Your Reference
SSD-83256478

**Beauchamp Road, Hillsdale, Affordable Housing — Response
to Submissions RFI #2**

Our Reference
703103419-009

Attachment 1: Revised Comments Register Response**1.1 Stormwater Management**

FIRA Revision F 1% depth and dry/wet map (Fig 5.19) showing wider extent.

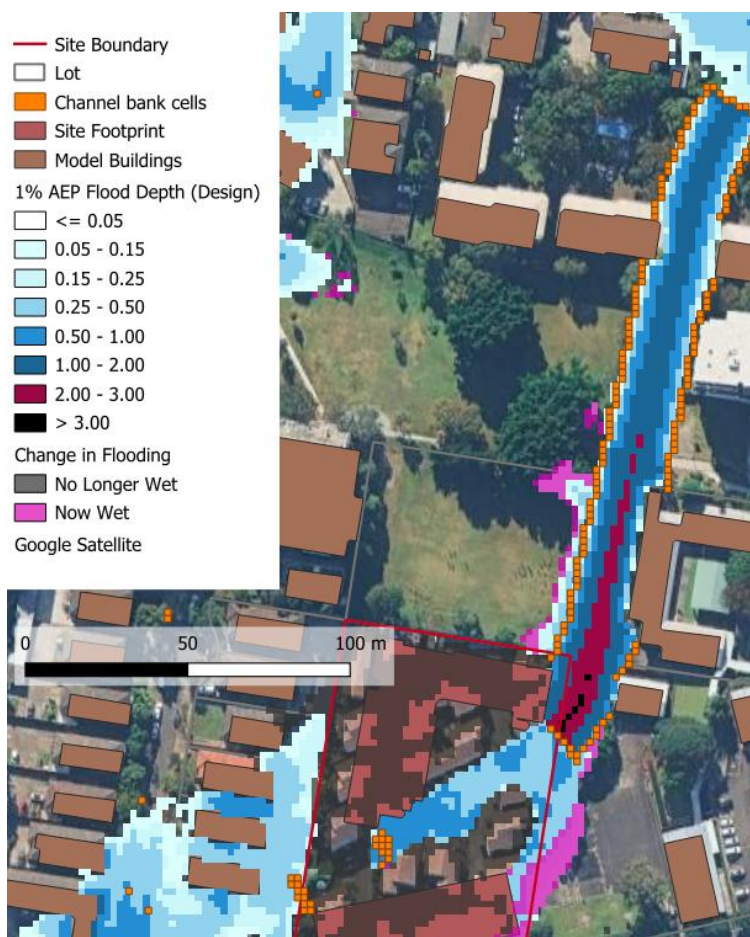
No.	Issue raised	Response
Bayside Council (Ref: SSD-2025/10)		
1	Revise the development design to reduce 1% AEP flood level increases on neighbouring properties to ≤10 mm afflux, in accordance with DCP controls.	Updated flood modelling indicates that post-development 1% AEP flood level increases on neighbouring properties are generally ≤10 mm. The Flood Risk Management Manual explicitly promotes proportionate assessment, requiring that the level of concern be with proportionate to the scale of impact and risk, rather than absolute avoidance of any change. In accordance with NSW floodplain risk management guidance, such minor localised exceedances occur at the stormwater channel edge and do not result in adverse flooding impacts to surrounding properties. The image below makes it clear that flow remains within stormwater channel or flow path within site, previous mapping was not as clear. The green and blue line overlays indicate where the SWC open channel extends to (green lines indicating centreline and cross-sections, blue lines representing bank tops). The 1% AEP afflux (image below) shows increase is contained within channel banks despite appearing as afflux on neighbouring site in the FIRA (revision E) mapping.  1% AEP Afflux image with stormwater culvert footprint overlay Additional assessment was completed following consultation on the extent and magnitude of 1% AEP impacts. FIRA (revision F) includes further mapping of the channel (reproduced here) to demonstrate the limits of the flood extent. The following figure represents the same 1% AEP Design Scenario flood depth output (shown on FIRA Figure 5.10) and wet/dry changes (shown on FIRA Figure 5.13) with additional overlay of the detailed flood model's bank cells which are the interface of grid represented floodplain and cross-section represented main channel flow. This figure:

- demonstrates flooding is wholly contained with the channel for the large eastern interface with the school site
- Indicates increases in ponded extent adjacent the channel (shown as pink “now wet” shading) occurs on the western bank, where the 1% AEP already inundates the park. Newly ponded areas are in the depth range of 0 to 0.15m,
- Indicates increases in ponded extent south of the channel headwall entry to below ground culvert (shown as pink “now wet” shading). This is located at the very south-western limit of the school site. Ponding in this lowest corner of the school site is typically up to approximately 0.5m depth (H1 to H2 hazard) under existing 1% AEP and remains typically H1 to H2 after development, with newly ponded area in the depth range of 0.1 to 0.2m.

Outside of these specific locations the impact to other properties is below 10mm of worsening.

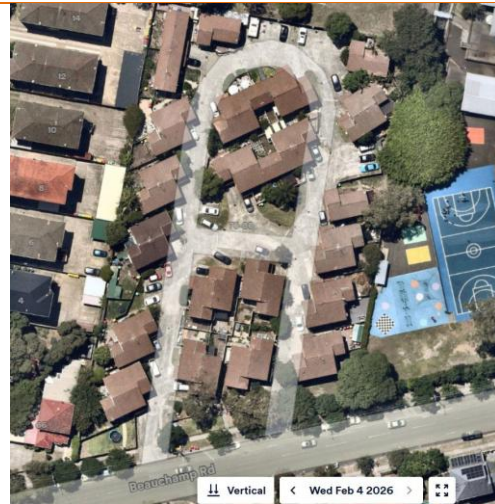
1	Compliance with SIP Clause 8(c)	A key requirement of the SIP is that the site is not located within High Hazard (H5 or H6) areas. There are many existing dwellings subject to high hazard in the PMF under existing conditions, including above floor level inundation. A recent aerial image indicates a significant population present (typically) from the large number of vehicles/garbage bins etc.
---	---------------------------------	---

With the proposed development, the extent of the H5 and H6 zones has reduced compared to existing conditions and does not encroach on the proposed building footprint or the nominated floor and basement levels.
